TOWN OF YARMOUTH
200 Main Street, Yarmouth, Maine 04096
www.yarmouth.me.us

**Planning Board Report
Modular Classroom
Final Building & Lot Plan and Major Site Plan
North Yarmouth Academy, Applicant
Map 32 Lot 111; SD1, NYA Campus Special District
Prepared by Erin Zwirko, Director of Planning and Development
Report Date: June 8, 2023; Planning Board Date: June 14, 2023**

To: Erin Zwirko, AICP, Director of Planning and Development
From: Steven Johnson, P.E., Town Engineer
CC: Erik Street, Nick Ciarimboli, Chris Cline, Wendy Simmons, Karen Stover
Date: June 5, 2023
Re: Major Site Plan Application: NYA Temporary Classroom, 148 Main Street

Front Elevation

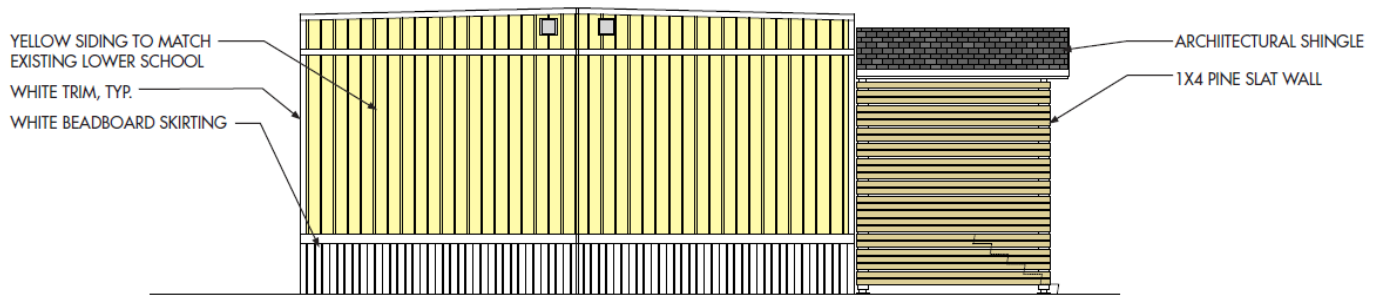
The proposed modular classroom is a temporary building providing additional capacity for NYA in the short-term. The modular classroom is a manufactured product, so there is little room for customization, although the school is proposing to match the siding color to the Lower School buildings:

Upper Story Height	10' Min, 15' Max	n/a	n/a
Façade Glazing	20% Min, 70% Max Shopfront: 70% Min	10.3%	Although the applicant did not request a waiver, it appears that a waiver is needed for the modular classroom.
Roof Type	Flat, Hip, Gambrel, Gable or Mansard	Flat	Ok.
Roof Slope	8:12 – 14:12 (.67 – 1.16), if any	Slight pitch	Ok.
